### **R E M A R K S**

Claims 1-15, 17-25, 39-48 and 50 are pending in this application. Claims 16, 26-38, 49 and 51 are cancelled. Claims 3, 6-12, 14, 15 and 22-24 are withdrawn from consideration.

*Fig. 7A*

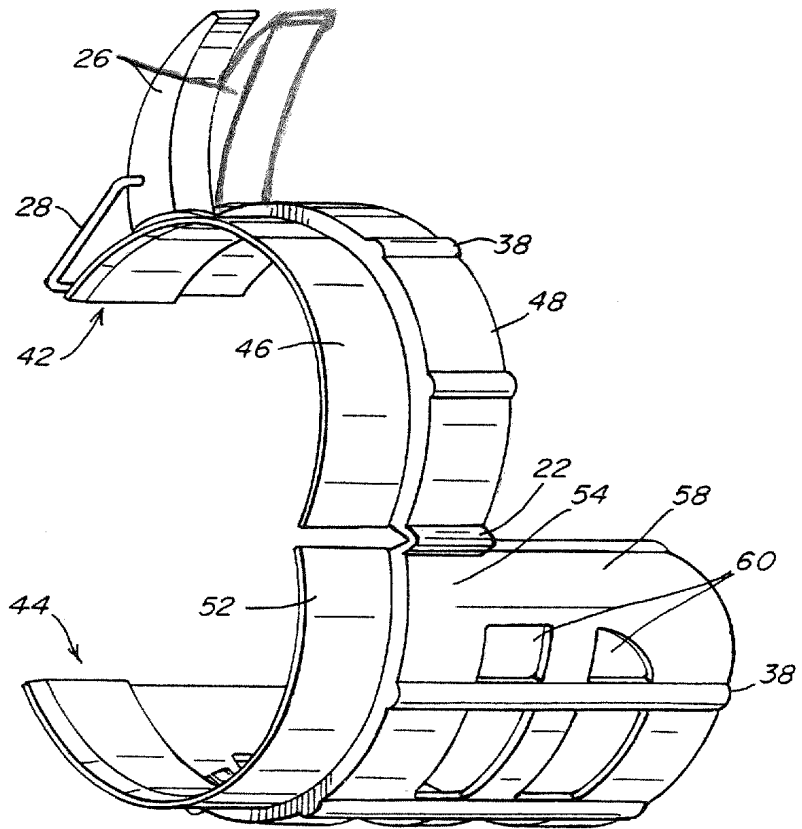
The drawings are objected to on the grounds that locking means on both the engagement portions is not shown.

Submitted herewith is proposed revised Fig. 7A wherein part

of the locking means is now shown on each engagement portion.
